## PLANNING AND ENVIRONMENTAL COMMISSION

**ITEM/TOPIC:** A request for review of Major Exterior Alteration, pursuant to Section 12-7B-7, Exterior Alterations or Modifications, Vail Town Code, to allow for an exterior remodel and additions to two units within Plaza Lodge, Unit R-1, located at 291 Bridge Street/Lots F-K, Block 5C, Vail Village Filing 1, and setting forth details in regard thereto. (PEC17-0004)

## Memorandum

SUBJECT: A request for review of Major Exterior Alteration, pursuant to Section 12-7B-7, Exterior Alterations or Modifications, Vail Town Code, to allow for an exterior remodel and additions to two units within Plaza Lodge, Unit R-1, located at 291 Bridge Street/Lots F-K, Block 5C, Vail Village Filing 1, and setting forth details in regard thereto. (PEC17-0004)

1 TOPOGRAPHICAL SURVEY  
1/8" = 1'-0"

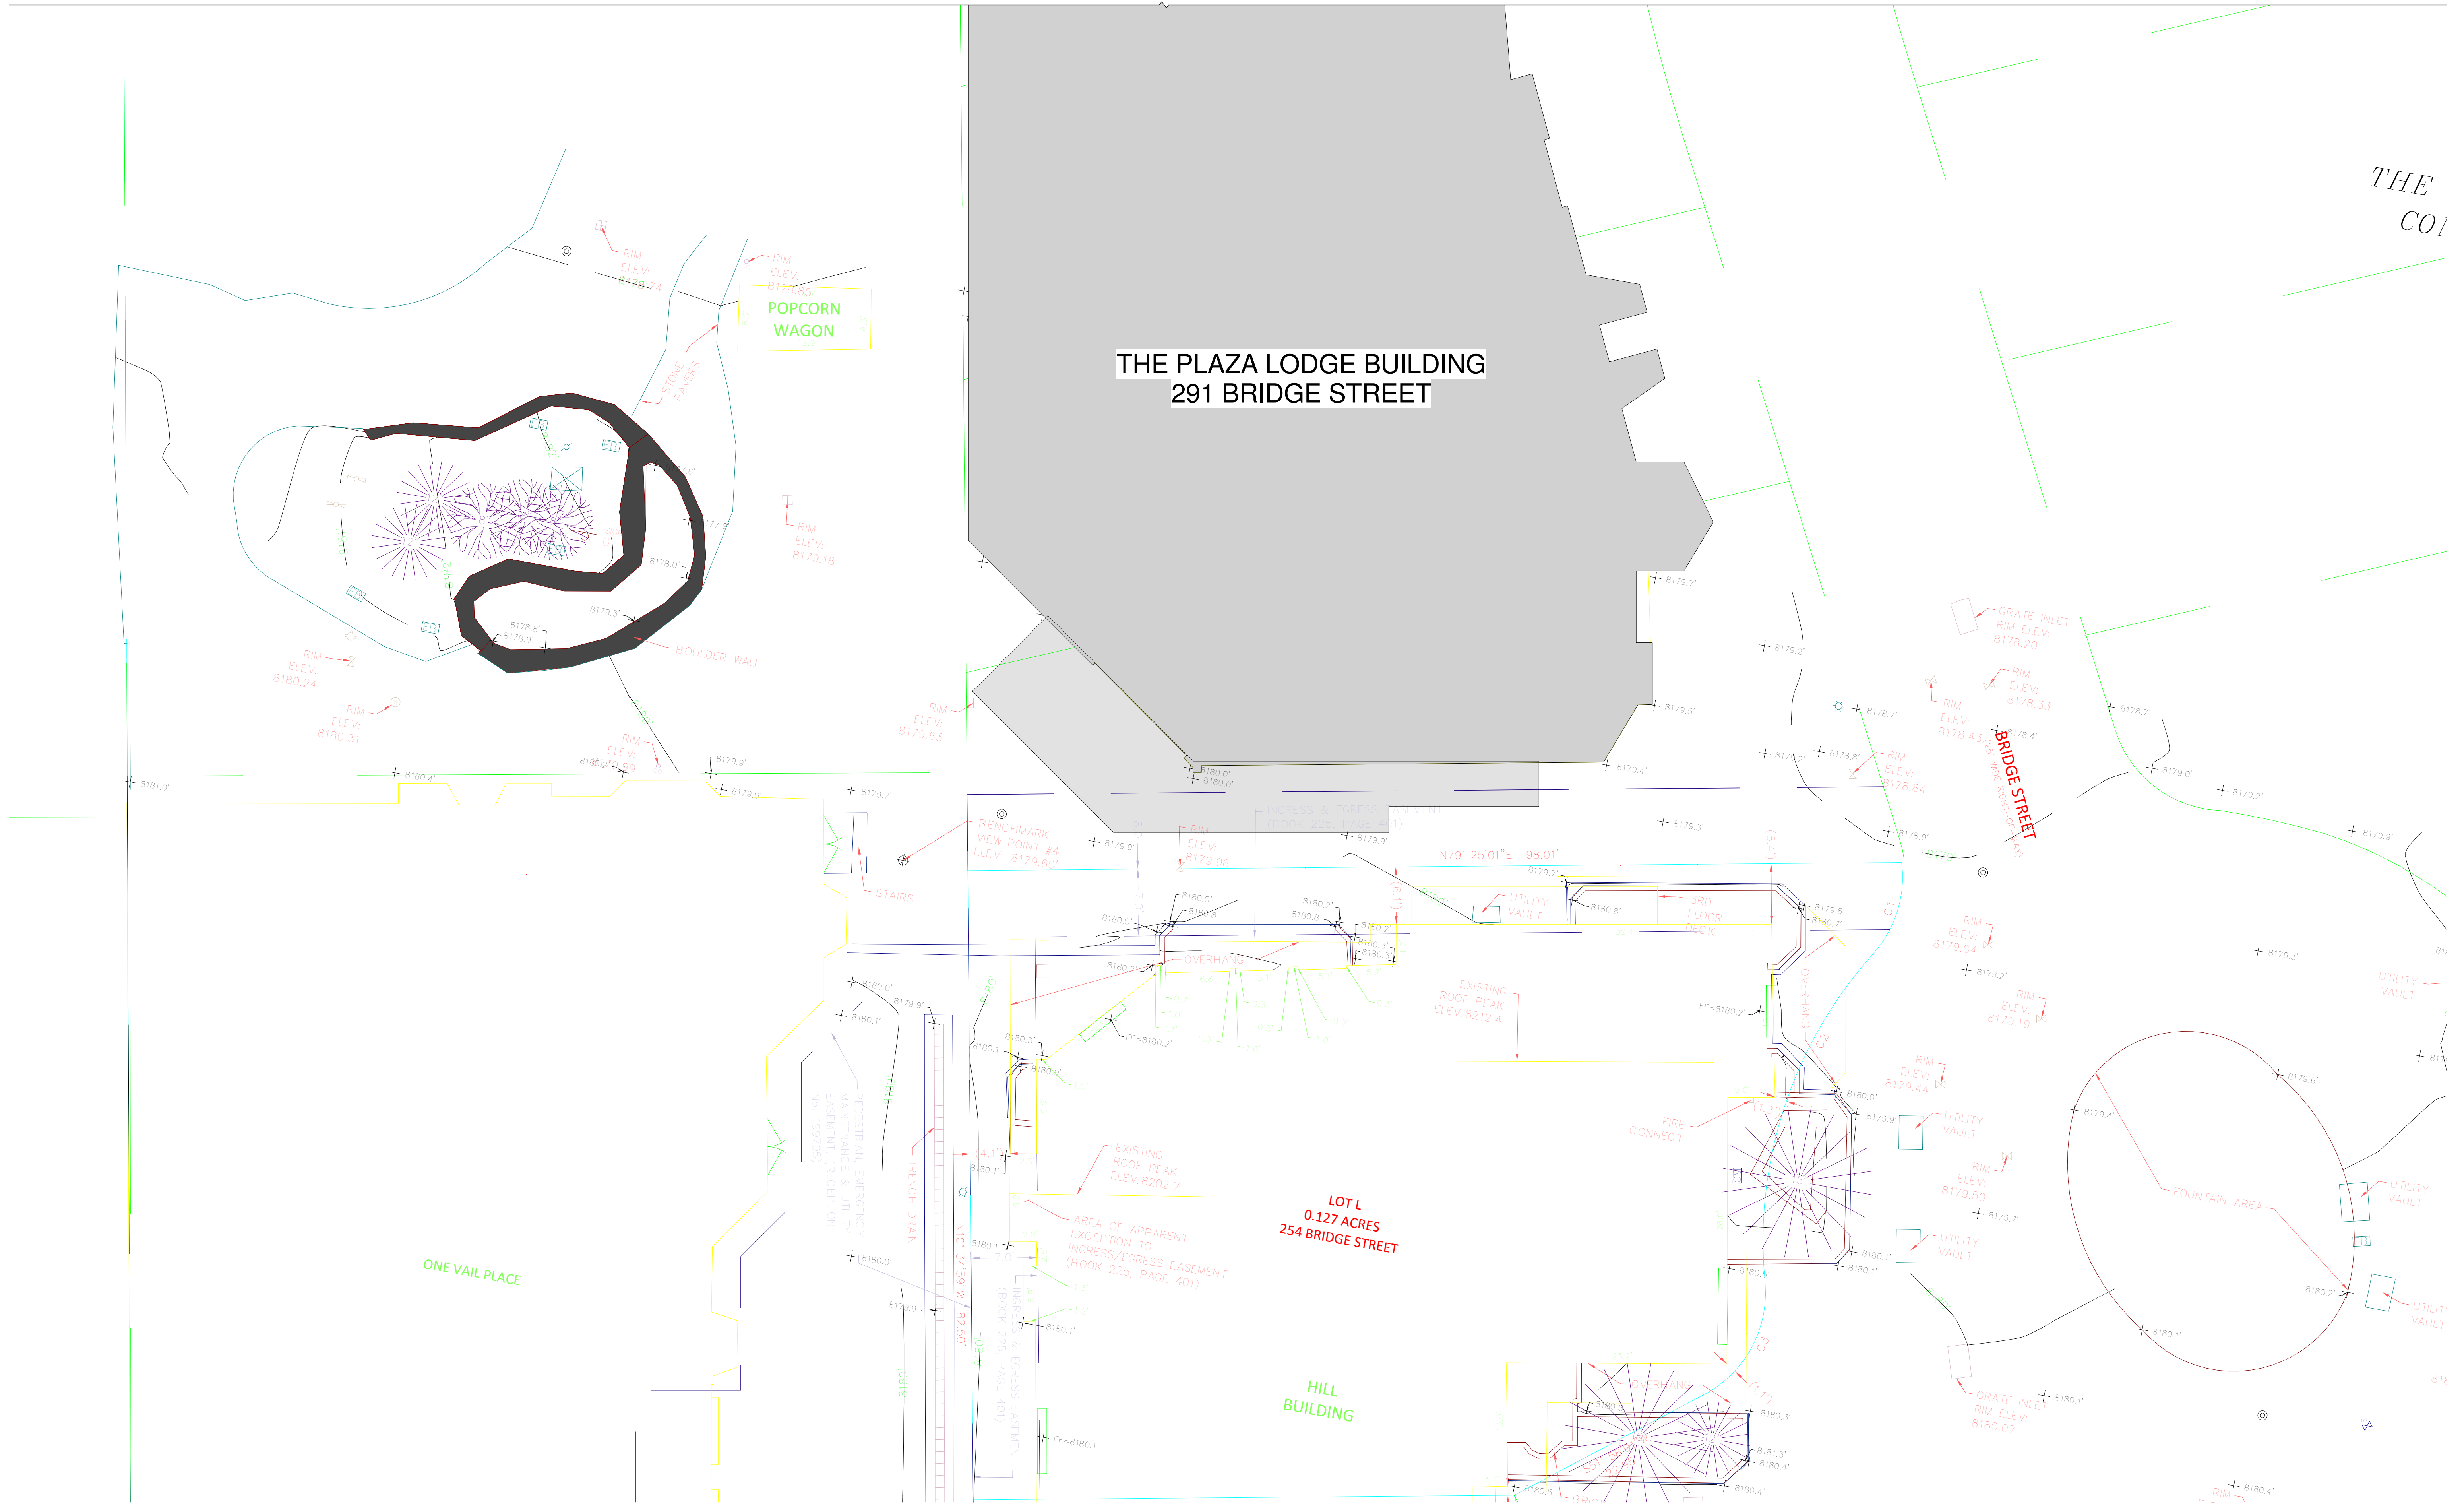
The proposal is intended to blend into the existing structure and all colors, materials, and finishes will match existing conditions and not negatively alter the character of the neighborhood. However, as mentioned in Criteria 1, based on the plans and documents submitted, it is unclear that the proposed improvements, specifically the third floor deck extension and roof fascia, will not encroach into View Corridor #4. Furthermore, Sheet A0-03A – Topographical Survey depicts an encroachment into a utility easement granted to the Town of Vail in 2004 and a pedestrian and vehicular ingress and egress easement granted to Vail Associates, Inc. in 1970. Should the applicant confirm proposed additions encroach into said easements, approval from the easements holders shall be required.

- 2. Prior to final approval by the Design Review Board, the applicant shall submit revised plans, including an updated and stamped topographic survey, depicting no encroachments into any existing easements. Alternatively, the applicant may submit written approval of encroachment by the easement holder;*

2 PROPOSED ROOF  
1/8" = 1'-0"

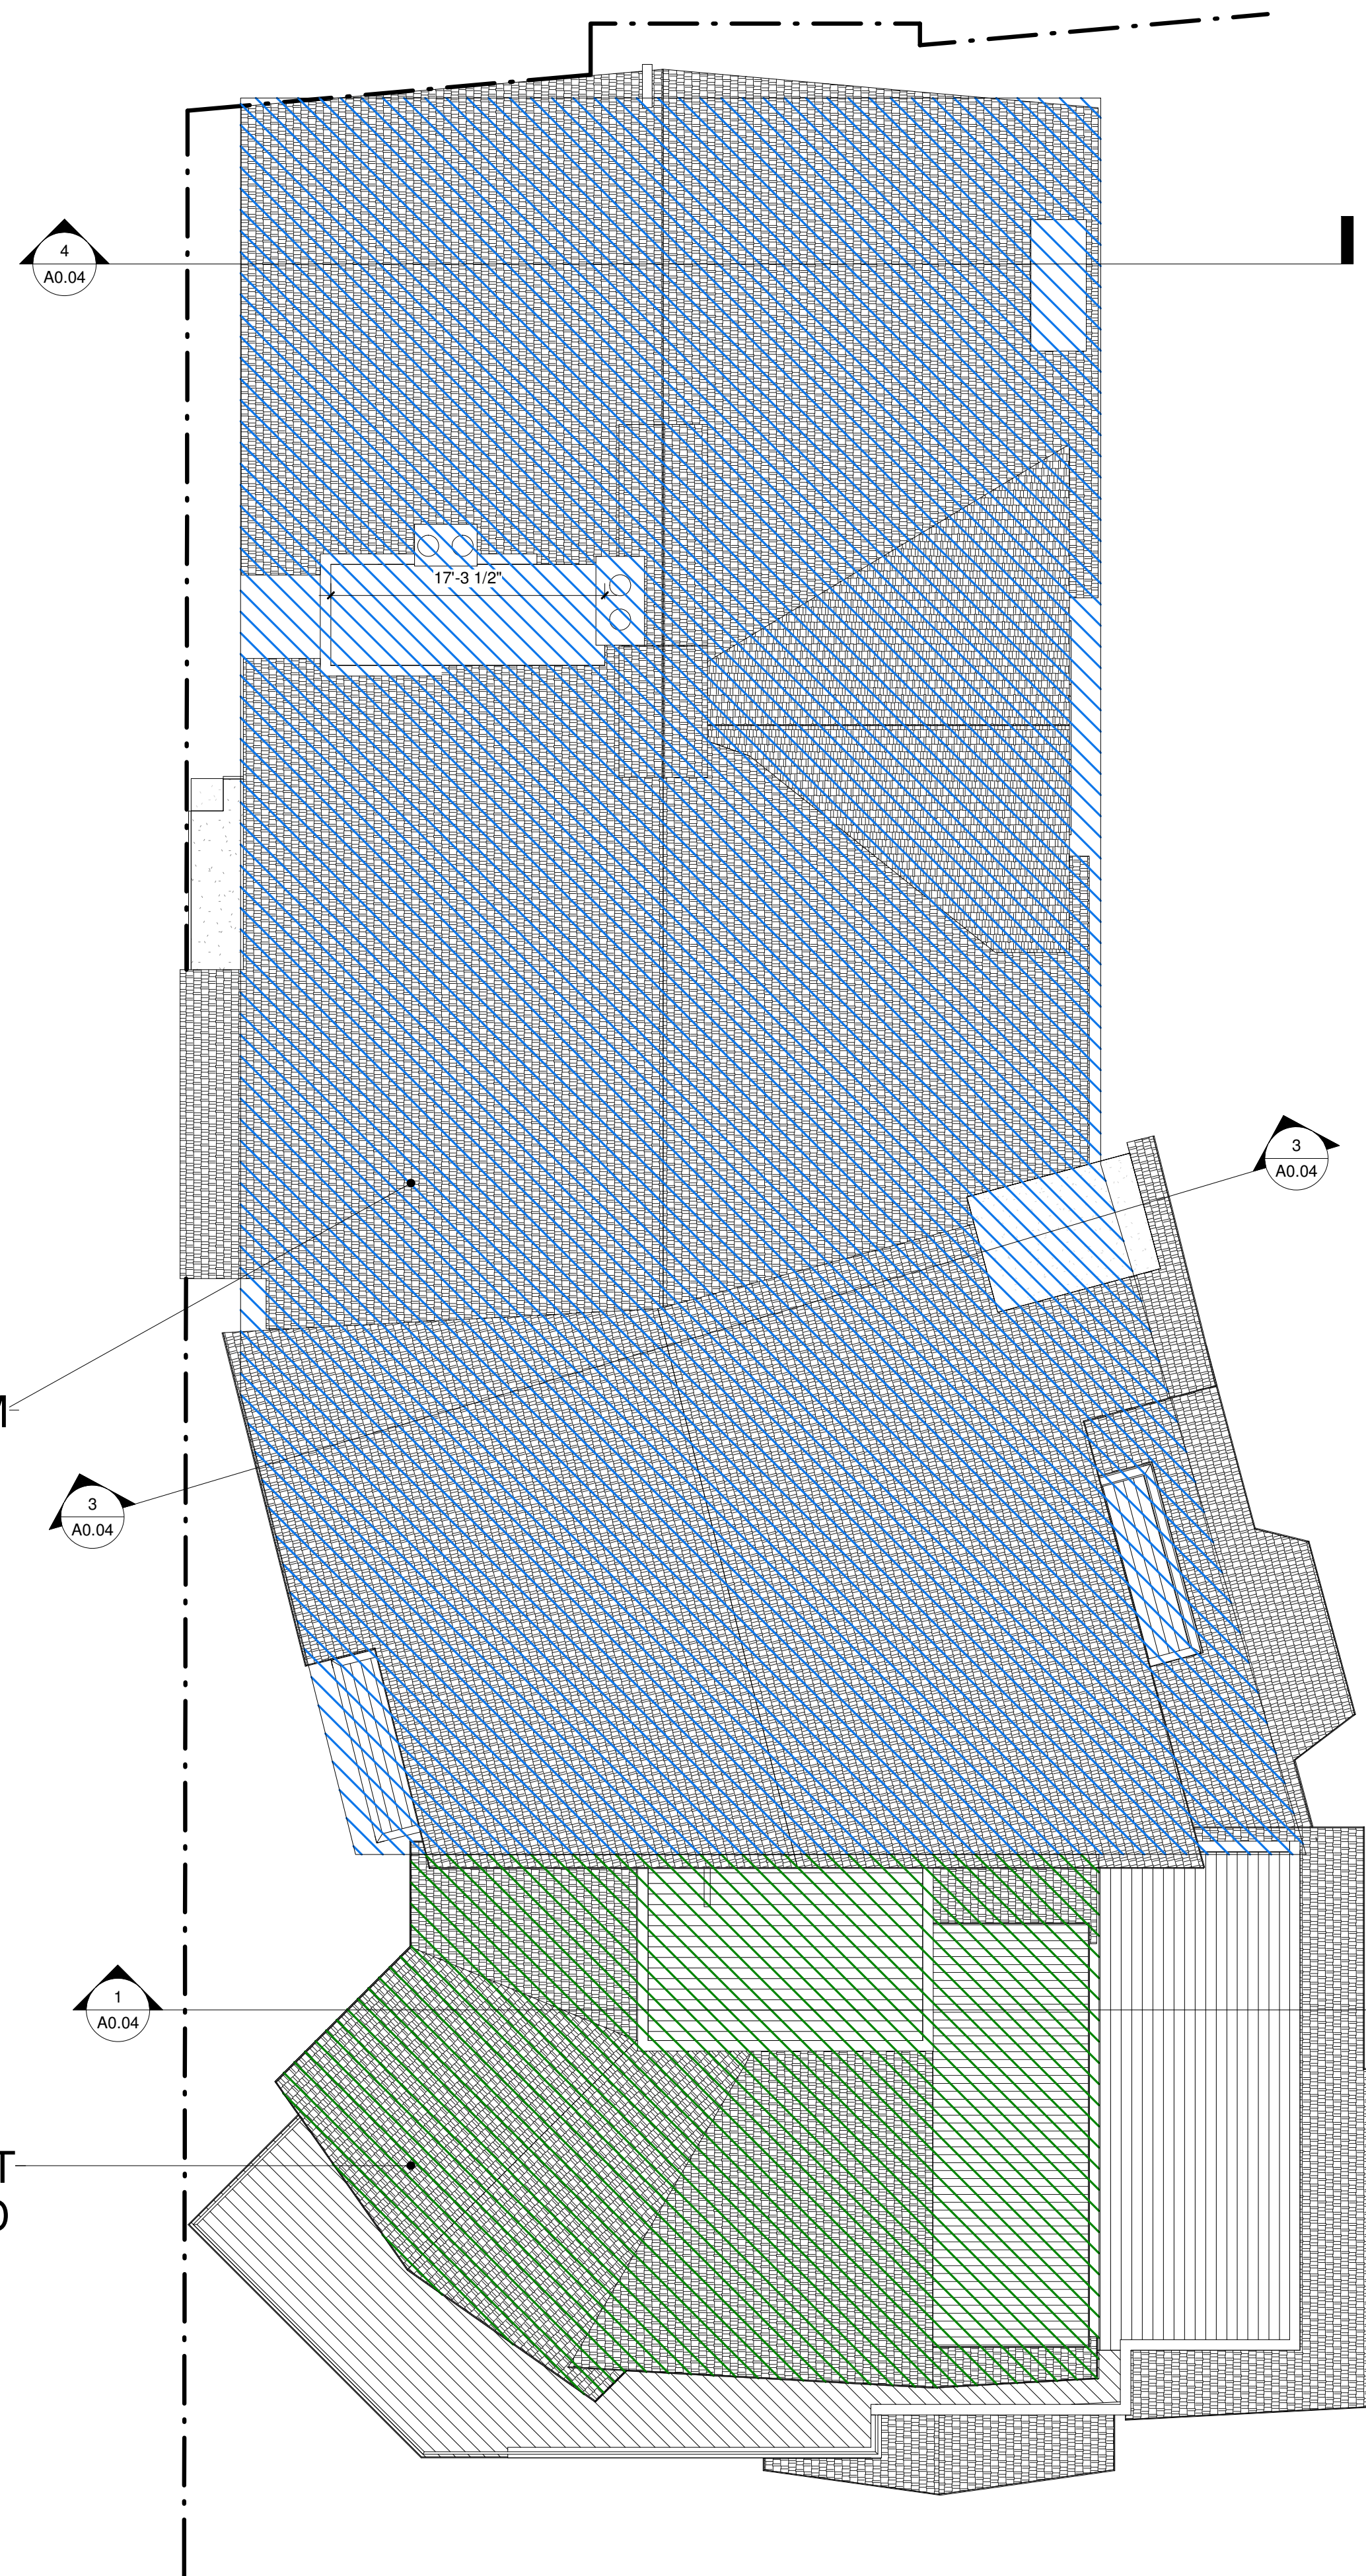
- Expanded living area, with new gabled roof, at the southwest corner of Unit R1-A (third floor);
- Other roofline modifications, including:
  - o The removal of two (2) roof areas, one at the west side of the structure above bedroom 1 of Unit R1-A (third floor), and another roof area removal at the east side of the structure above the proposed master bedroom of Unit R1-A (third floor);

- o Modification to the existing roofline at the south side of the structure from two (2) shed roofs to one (1) gabled roof with a shed dormer on the east side of the new gable; and

With the exception of a proposed standing seam metal roof on a portion of the east façade, the proposed additions will use matching materials, colors, and finishes from the existing building. In order to maintain consistent roof forms and materials, staff suggests that the proposed shed roof dormer on the east façade be modified in such a
